**SECOND AMENDMENT TO REVOCABLE
AND NONEXCLUSIVE LICENSE
(CONFLUENCE EAST IMPROVEMENTS)**

Confluence East Improvements

CONFLUENCE PARK

**CONFLUENCE
PARK EAST**

L4.01

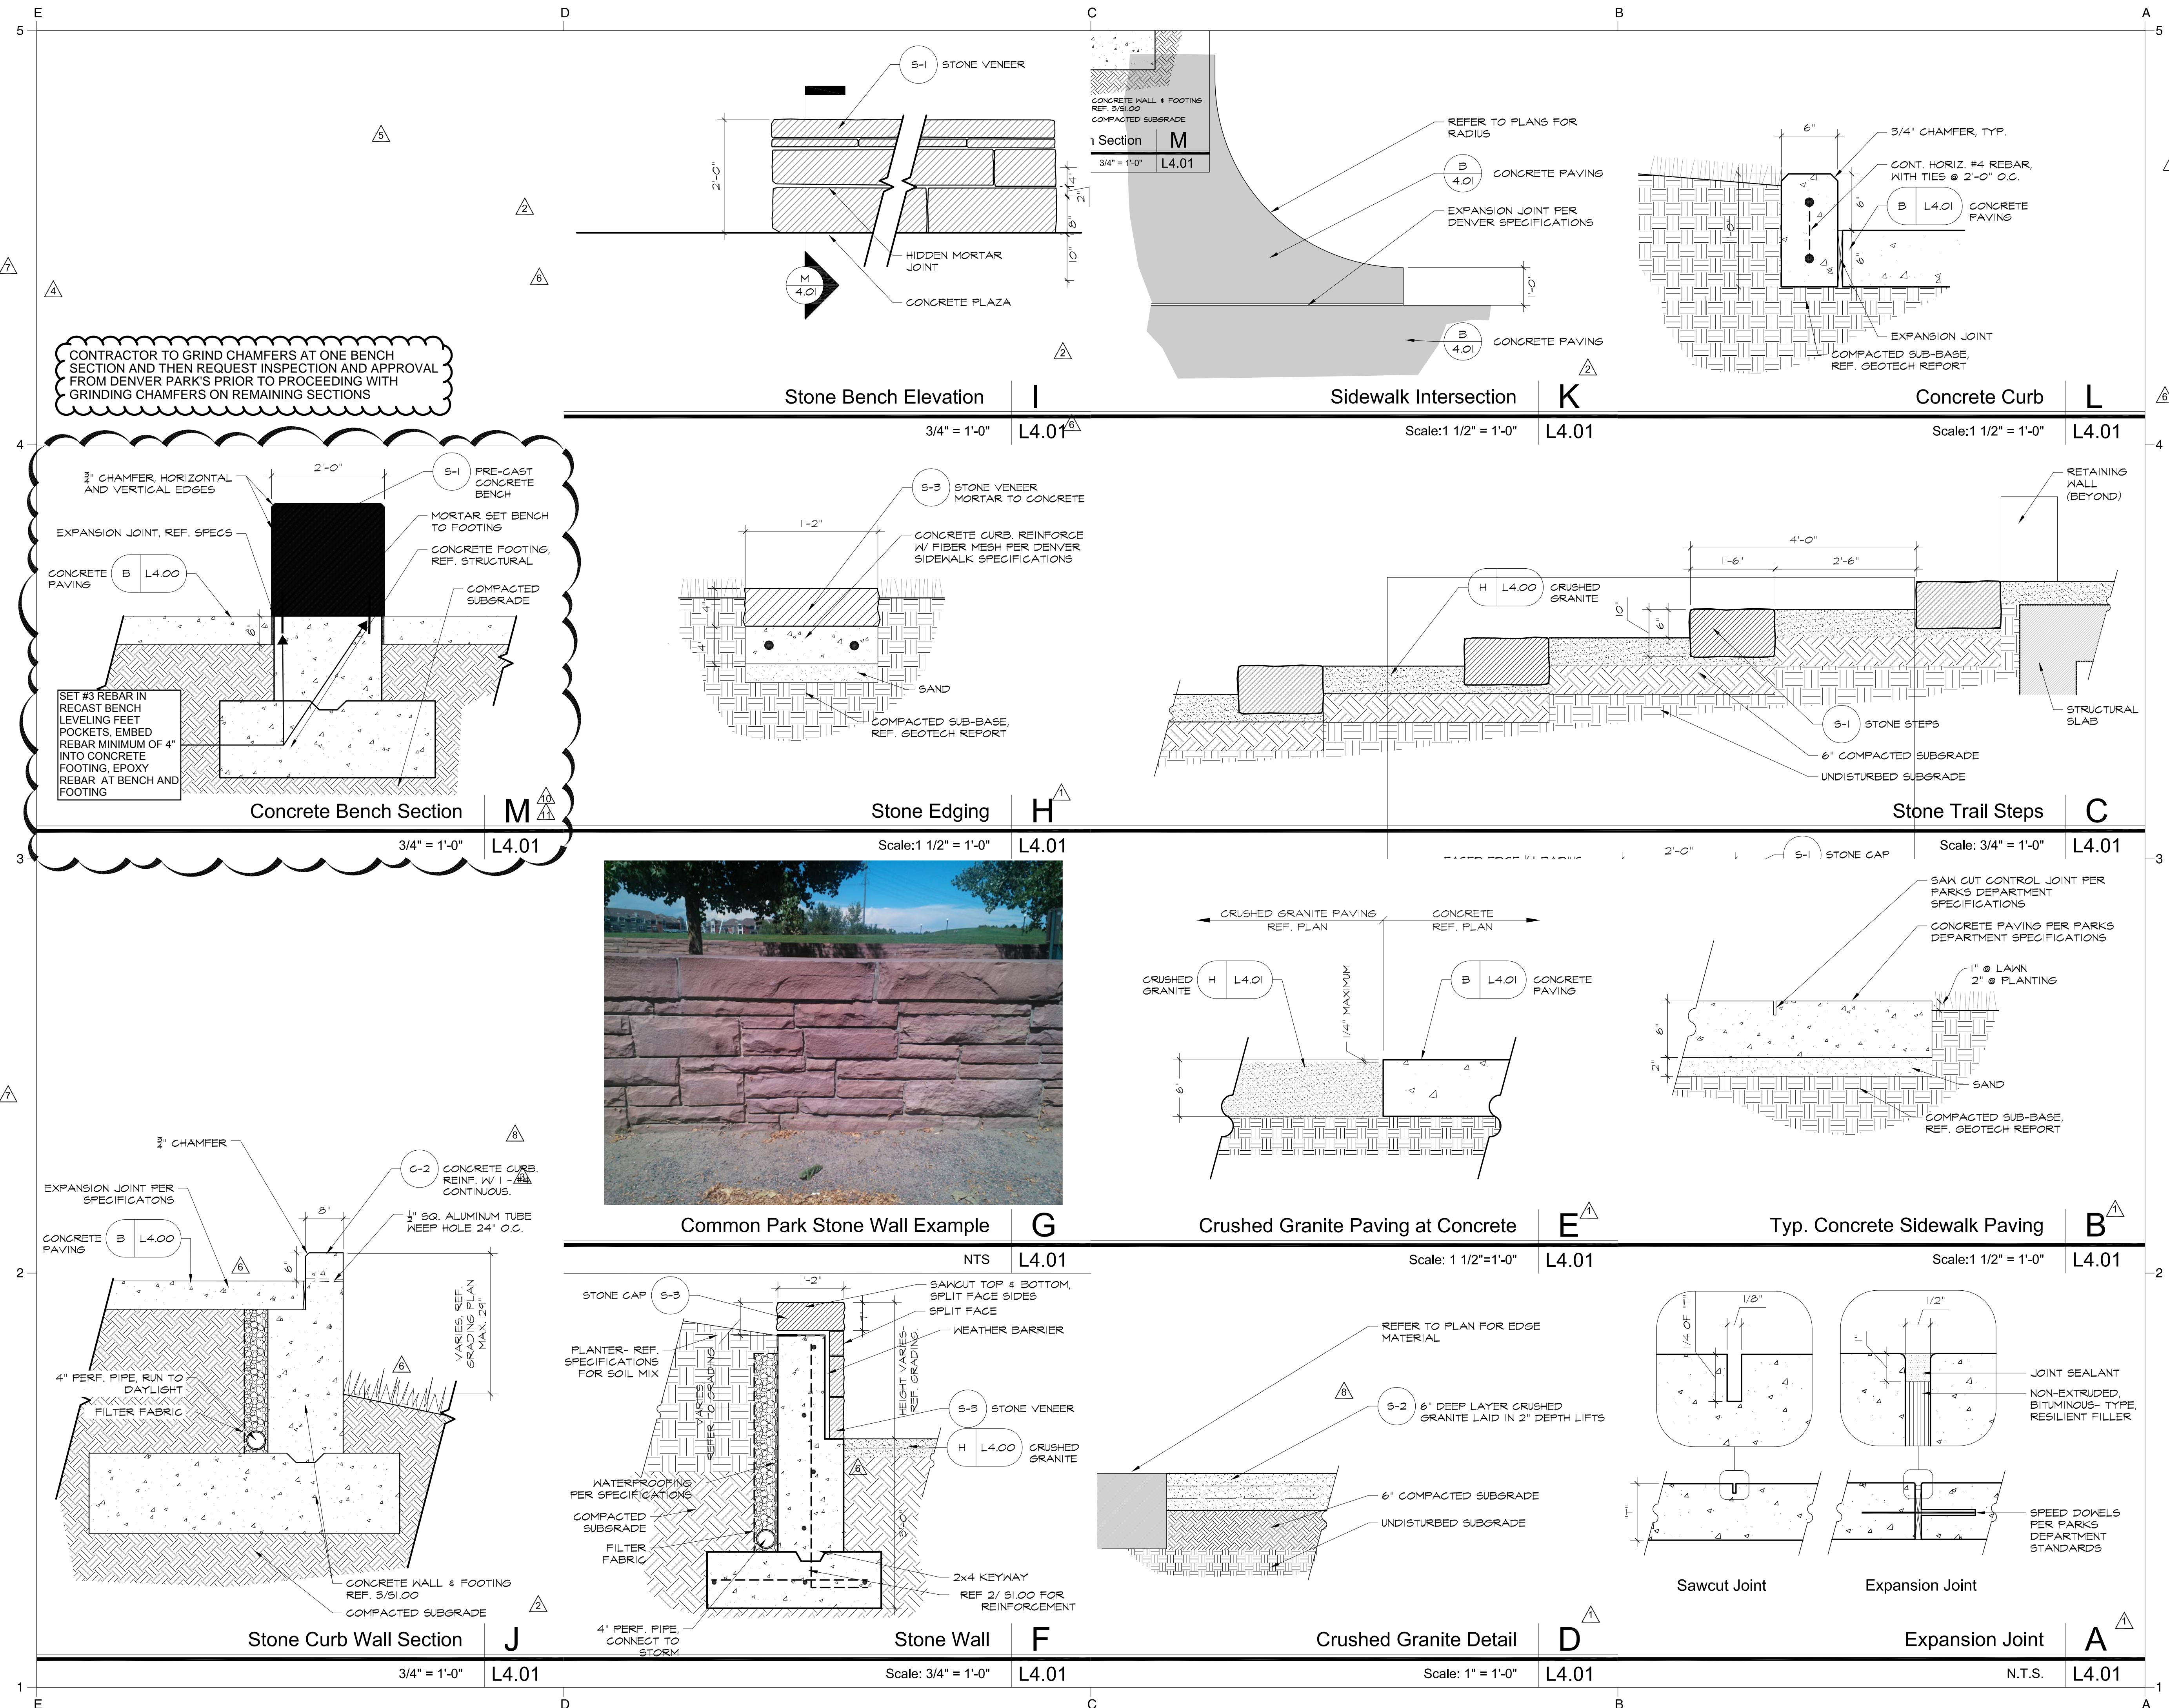
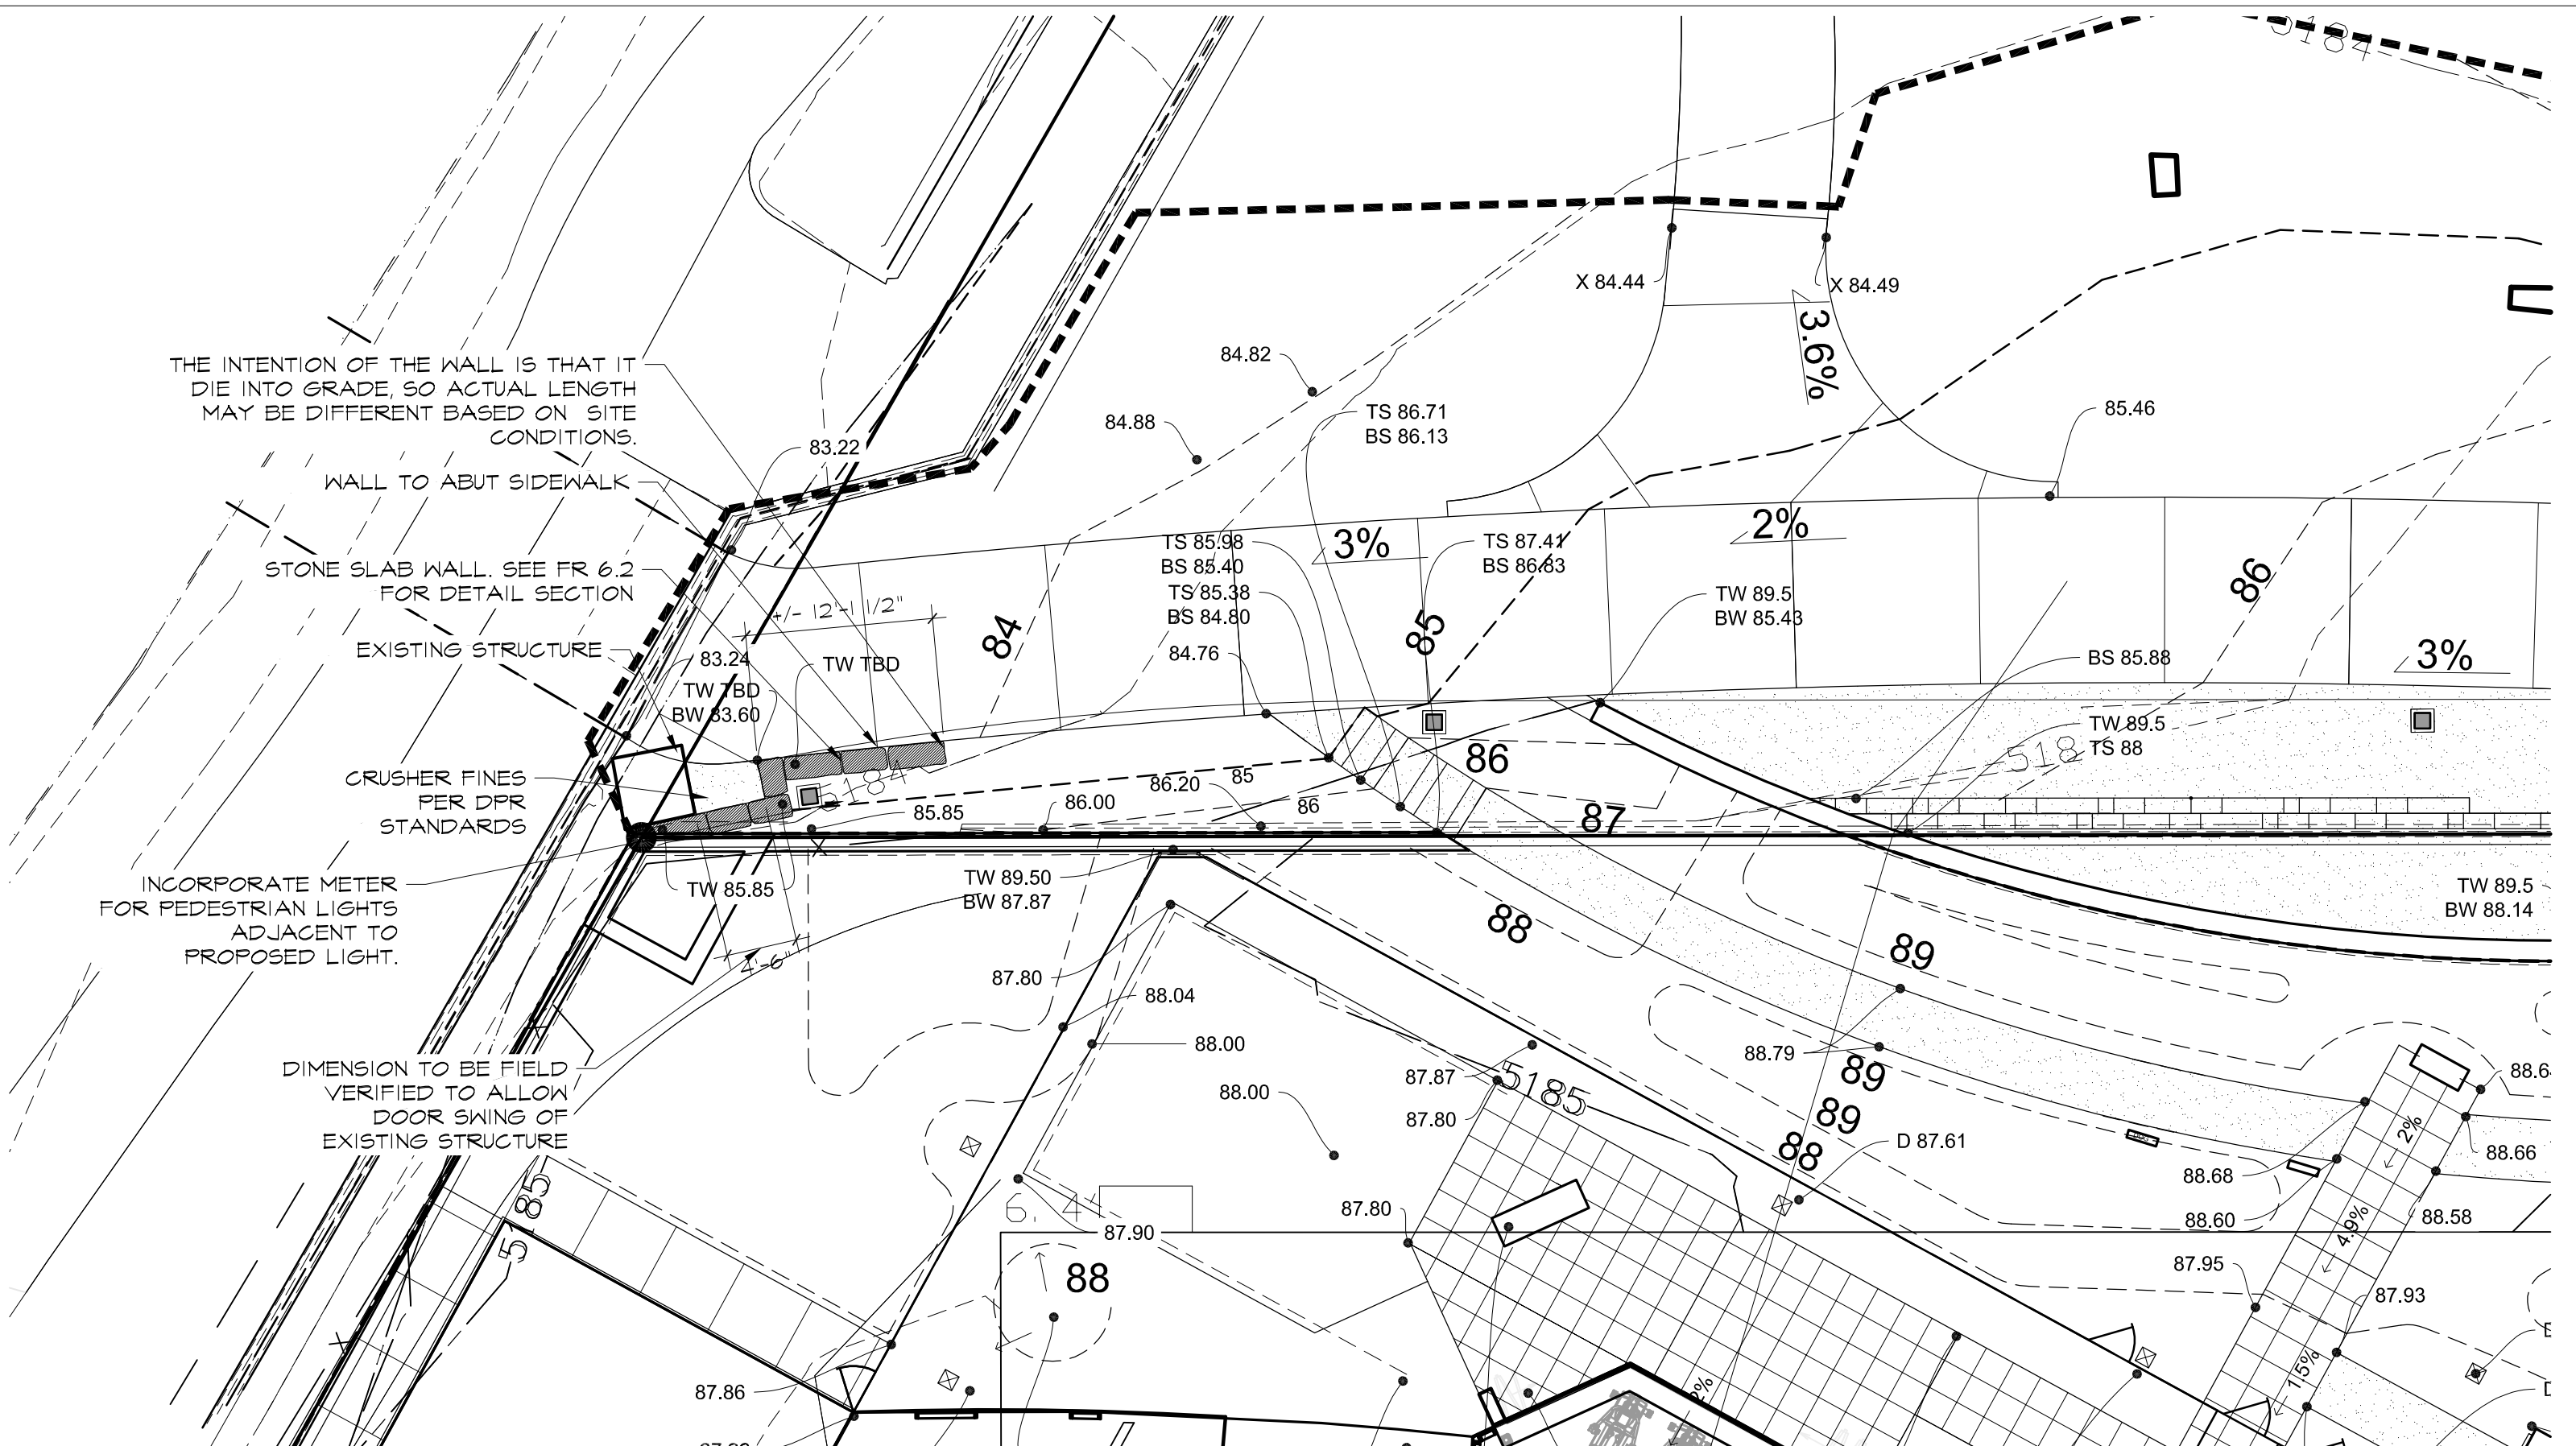
ASI 26-R8
11/16/2017

CONTRACTOR TO GRIND CHAMFERS AT ONE BENCH SECTION AND THEN REQUEST INSPECTION AND APPROVAL FROM DENVER PARKS PRIOR TO PROCEEDING WITH GRINDING CHAMFERS ON REMAINING SECTIONS

3/8" CHAMFER, HORIZONTAL AND VERTICAL EDGES
2'-0"
S-1 PRE-CAST CONCRETE BENCH
MORTAR SET BENCH TO FOOTING
CONCRETE FOOTING, REF. STRUCTURAL
COMPACTED SUBGRADE
CONCRETE PAVING B L4.00
EXPANSION JOINT, REF. SPECS
SET #3 REBAR IN RECAST BENCH LEVELING FEET POCKETS. EMBED REBAR MINIMUM OF 4" INTO CONCRETE FOOTING. EPOXY REBAR AT BENCH AND FOOTING
